# 21555 Non-Transparent PCI-to-PCI Bridge

Specification Update

*December 2002*

Order Number: [278337-008](#)

Figure 1. Node Boundary

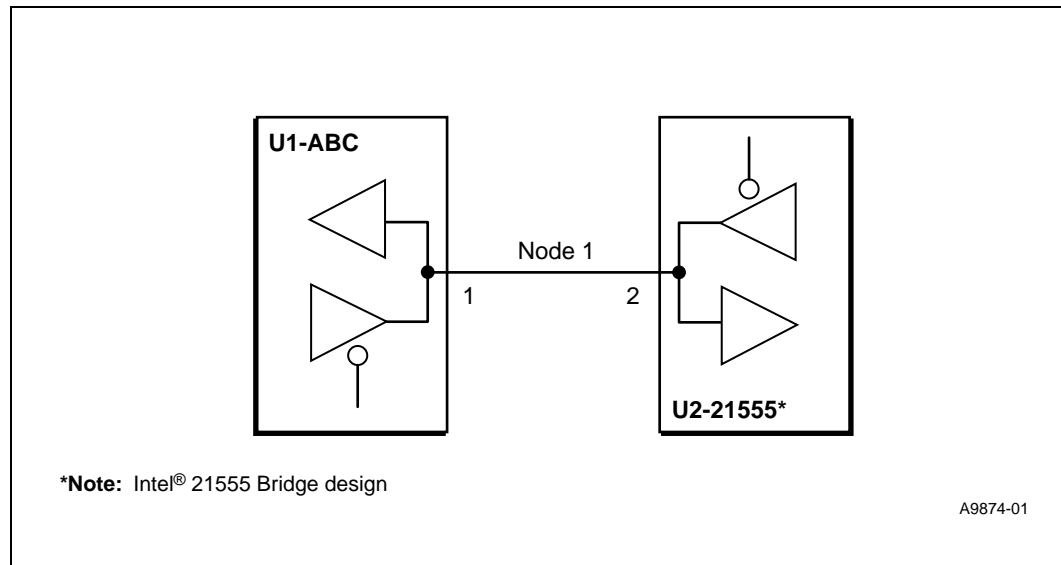
### 1. **21555AA/BA boundary Scan Implementation is not compliant with IEEE 1149.1**

**Problem:** There is a one cycle delay before valid BSDL data is pushed out to the pins. The problem is due to an incorrect inversion in the equation that generates the JTAG update.

**Implication:** The parallel output data from any bi-directional pins, purely output pins or control cells, will be driven out exactly one clock after the UPDATE state. This is in violation of the IEEE1149.1 Specification.

To understand the potential issue in detail, refer to the diagram below. Node 1 is a bi-directional node, with U1.1 and U2.2 connected as shown. Assuming that U1 is an IEEE1149.1 compliant device, that U2 is the 21555, and that the control cells of the 21555 were set during the vectors to enable the driver of U2.2 to drive to U1.1 (receiver). When switching drivers from U2 to U1, U2 should tri-state its driver prior to, or at the same time as, U1 enables its driver. Since the 21555 UPDATES its Parallel Outputs one clock late and the control cells which enable U2's drivers are Parallel Outputs which again updates one clock cycle late then U2.2, which will be driving at the same time U1.1 is driving. This contention will happen for one TCK cycle, until U2 UPDATES its parallel outputs. The period of this contention is dependent on the TCK frequency rate.

**Workaround 1:** In-Circuit testers should test for the parallel output data to be on the pins of the chip, at least one clock after the UPDATE state. Typically Automated Test Pattern Generator (ATPG) test vectors will test for this state upon exiting the UPDATE state. This test should be delayed one clock from the ATPG vectors. Also, In-Circuit testers should ensure that data is driven onto pins of the 21555, one clock after UPDATE, to avoid any potential of back driving a pin.

**Workaround 2:** Standalone boundary scan testers and In-Circuit testers performing chained boundary scan tests, should understand that the Parallel Output UPDATE data, being delayed by one clock, may cause bus contention and back driving during that one clock period, assuming the vectors change bus driving sources in one vector. This is because in chained boundary scan tests, all components execute TAP instructions in Parallel (or lock step), and vector generation algorithms optimize the number of vectors.

A remedy to the 21555's late UPDATE is to ensure the chained Boundary Scan tester's vectors do not switch bus driver directions in one vector. This means that one vector should disable U2's driver, and the next vector should enable U1's driver. ATPG vectors typically are not manually manageable in this way and this requirement may force an engineer's manual intervention. No single stepping of test clock through the TAP State Machine should be allowed with the 21555 in the boundary scan chain. The resulting contention would increase the potential back drive time, increasing the possibility of device damage.

**Status:** Fixed. This behavior has been corrected in the 21555AB/BB Step A3 device.

**Figure 12-1. Signal trst\_I States**

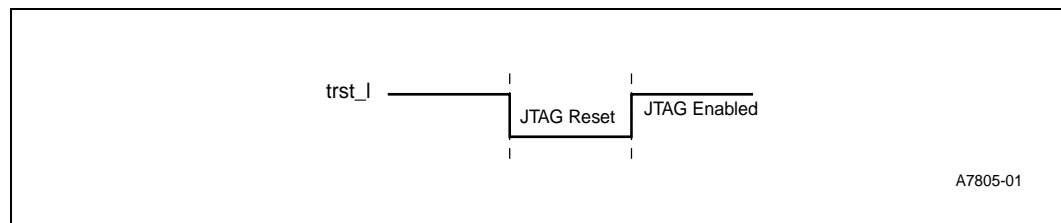
**13. Change to Initialization Section 12.2.1 and JTAG Description**

**Issue:** Change to second paragraph. Also made a change to normal operation description note for JTAG below Figure 12-1. The section now appears as follows:

The test access port controller and the instruction register output latches are initialized and JTAG is disabled while the **trst\_I** input is asserted low (see Figure 12-1). While signal **trst\_I** is low, the test access port controller enters the test-logic reset state. This results in the instruction register being reset which holds the bypass register instruction. During test-logic reset state, all JTAG test logic is disabled, and the device performs normal functions. The test access port controller leaves this state only after **trst\_I** (low) goes high and an appropriate JTAG test operation sequence is sent on the **tms** and **tck** pins.

For the 21555 to operate properly, the JTAG logic must be reset. The controller resets:

- Asynchronously with the assertion of **trst\_I**.
- Synchronously after five **tck** clock cycles, with **tms** held high.

**Note:** Prior to normal 21555 operation, this signal must be strobed low or pulled low with a 1kΩ resistor.
